CONSTRUCTION PLANS
FOR
THE RIDGE AT LORSON RANCH FILING NO. 3

STREET & STORM SEWER CONSTRUCTION PLANS

Construction Drawings (PlansProfiles)_v3.pdf Markup Summary

STREET / STORM - NORTH AREA
 REAGAN RIDGE DRIVE
 STA 1+95 TO 7+50

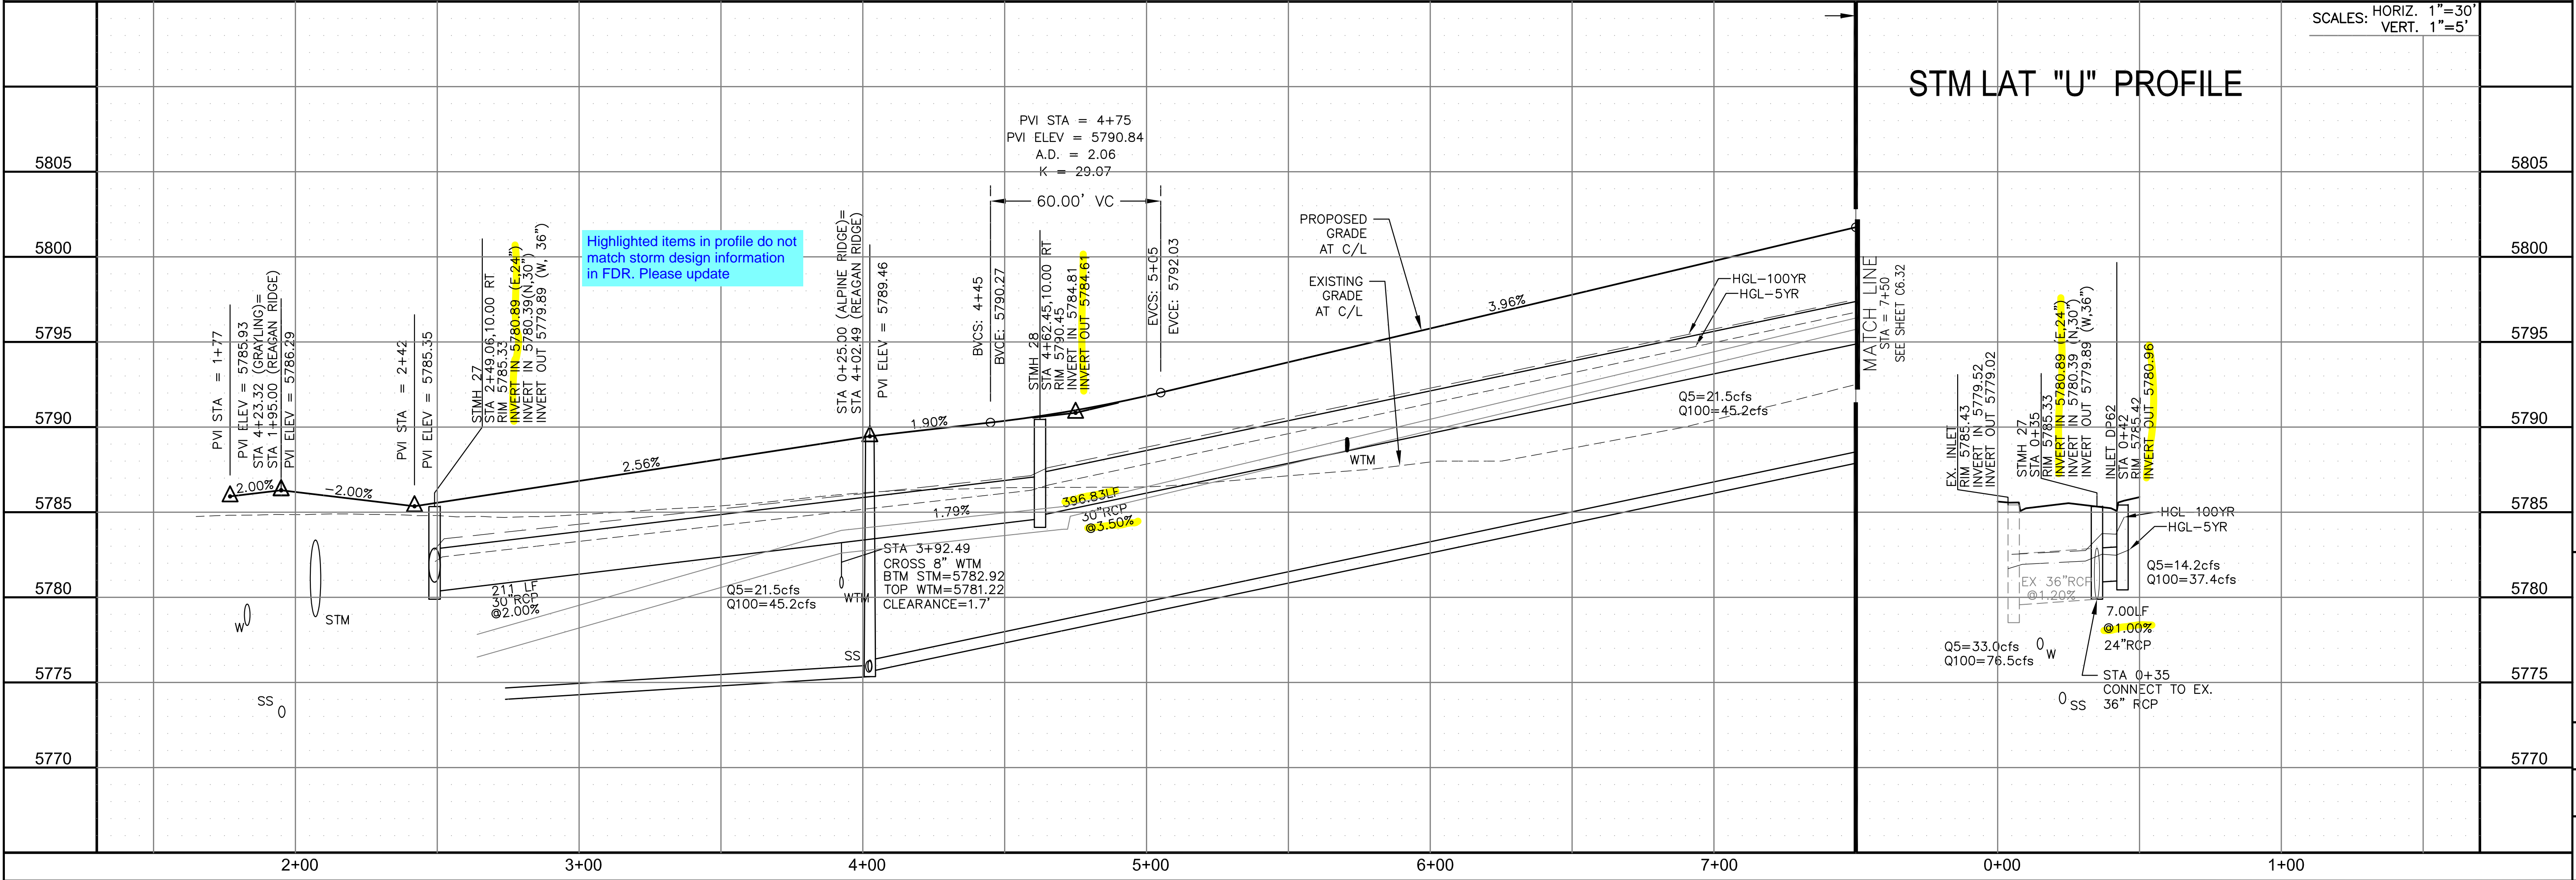
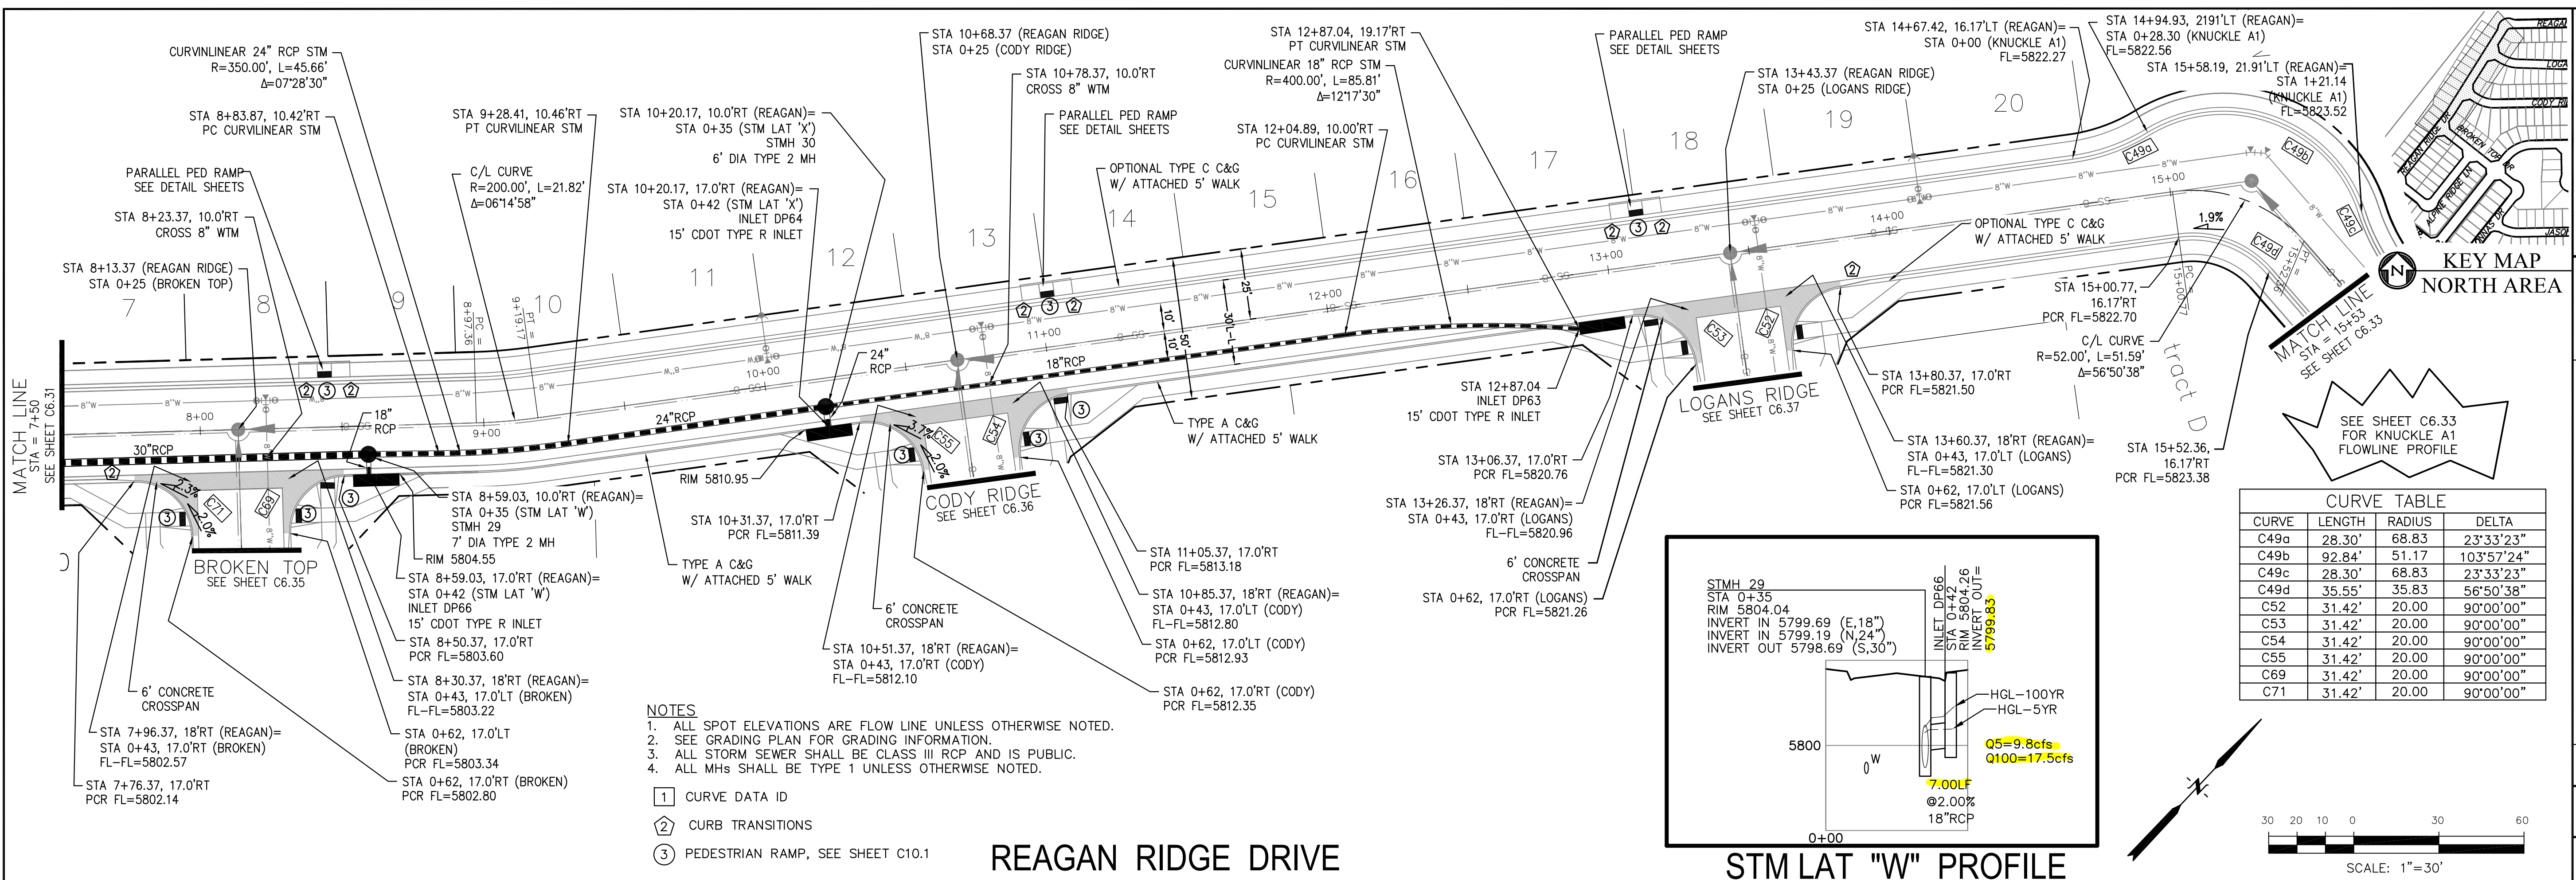
Sta labels do not match for Reagan

STREET / STORM - NORTH AREA
 BROKEN TOP DRIVE
 STA 0+00 TO 6+72

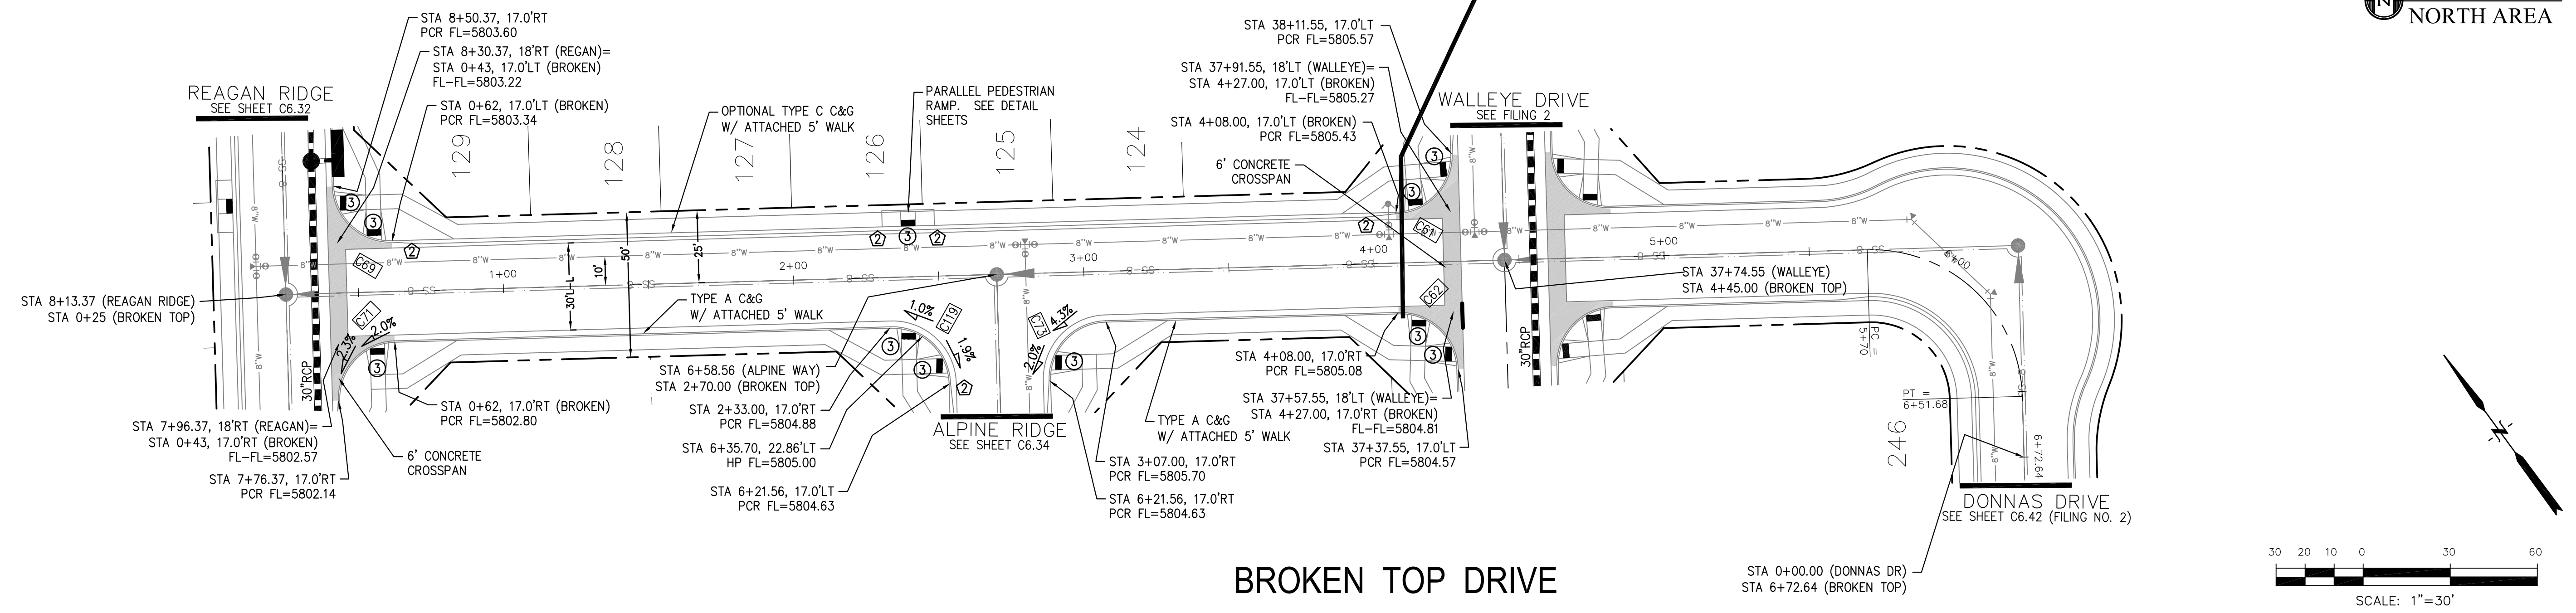
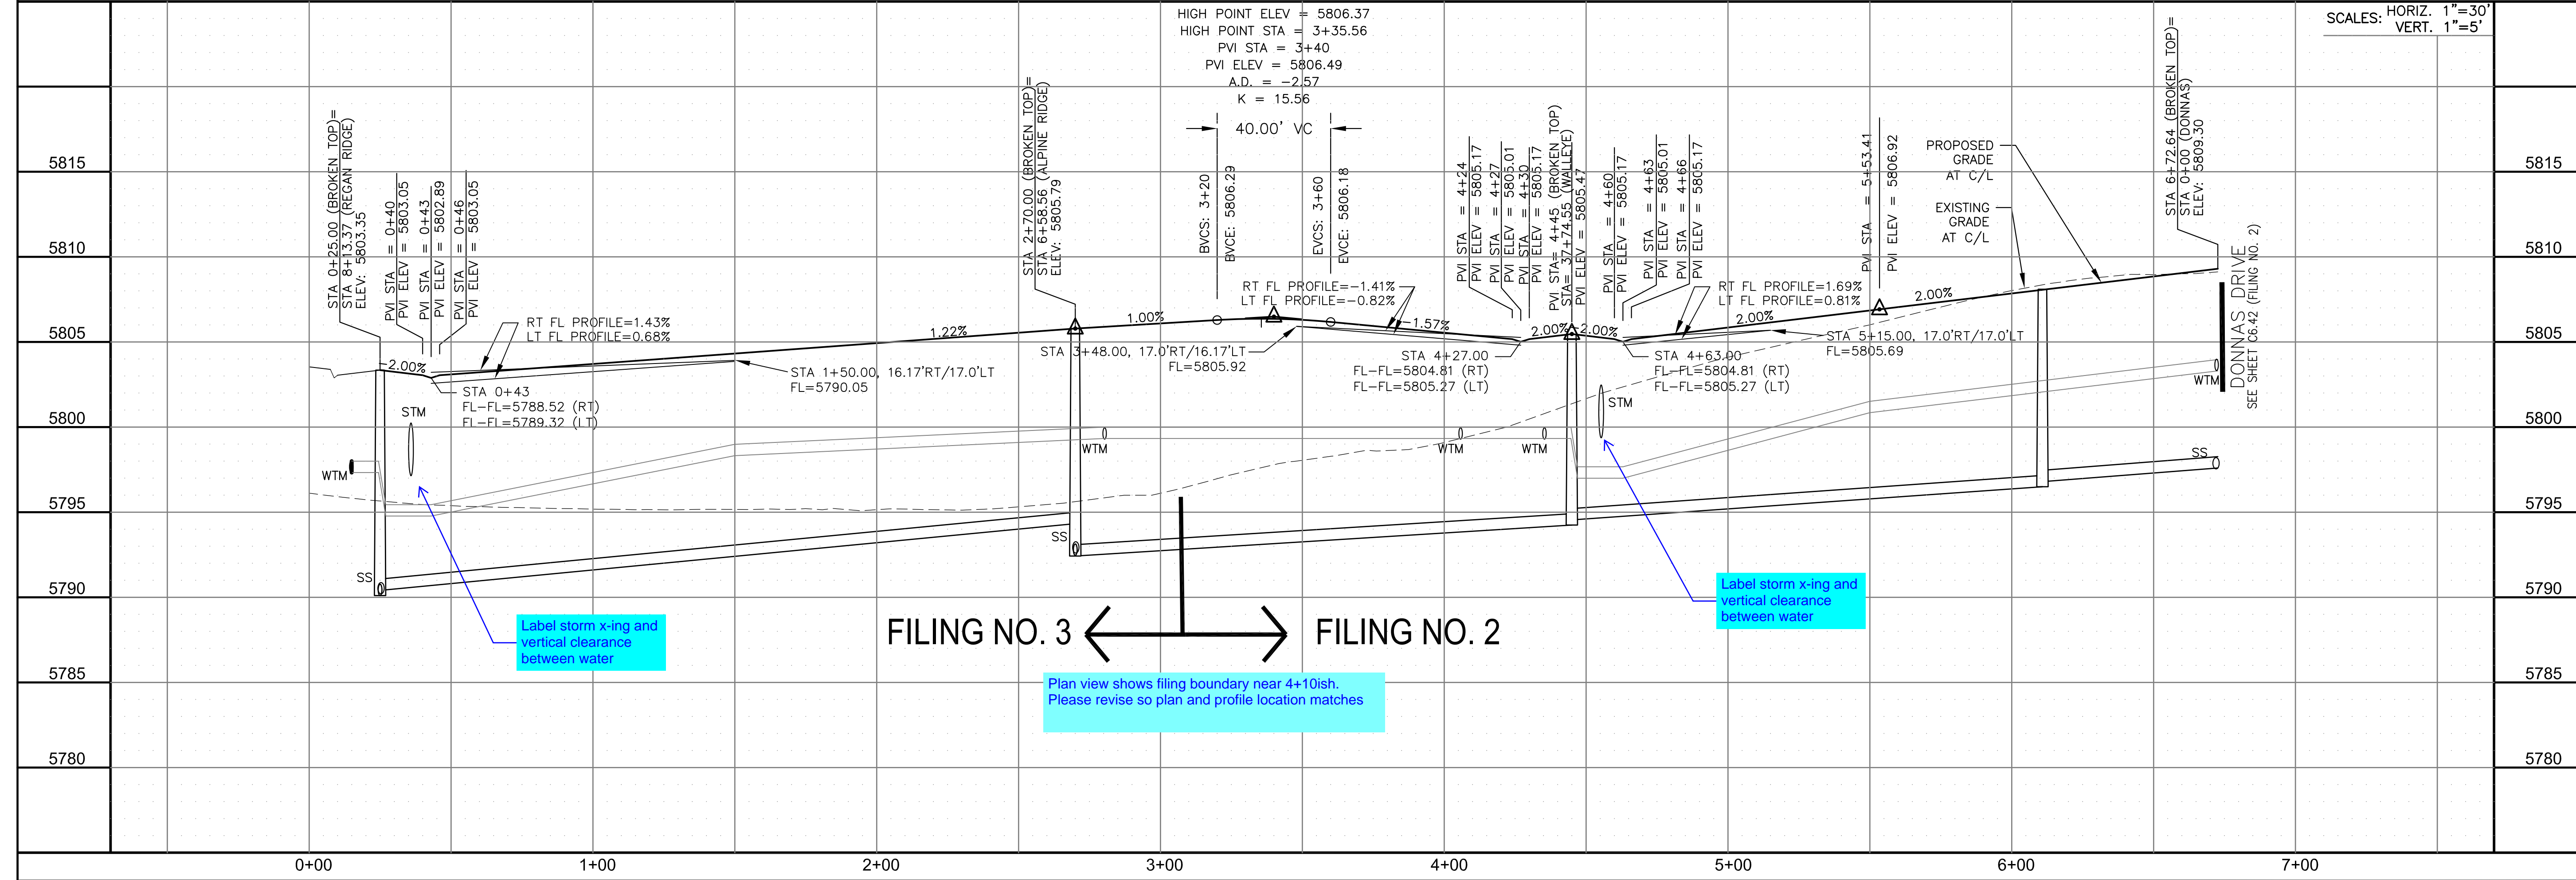
Label storm x-ing and vertical clearance between water

Plan view shows filing boundary near 4+10ish. Please revise so plan and profile location matches

Label storm x-ing and vertical clearance between water

STREET / STORM - NORTH AREA
WALLEYE DRIVE / RIKERS RIDGE LANE
STA 45+00 TO 52+87

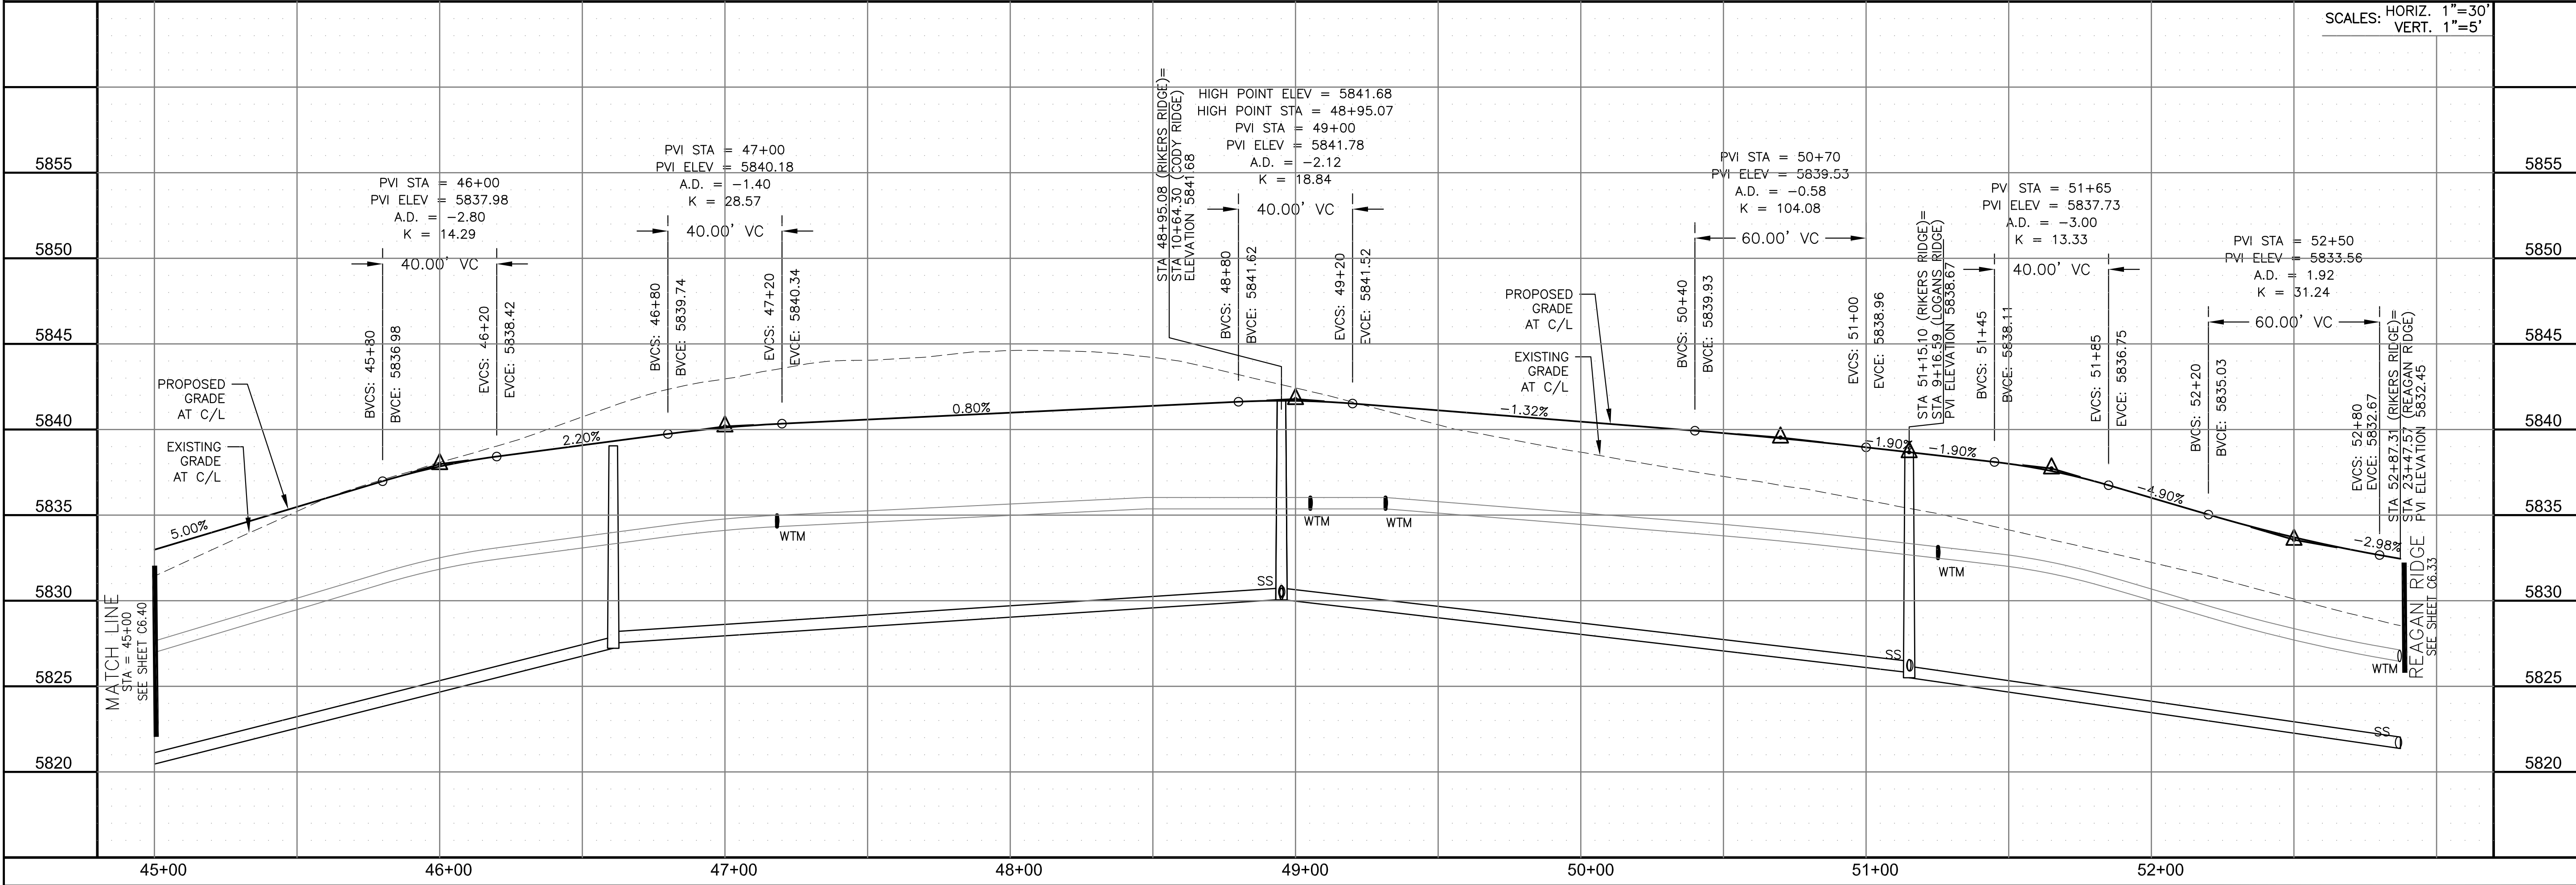
Include CL-CL sta label for Walleye & Rikers
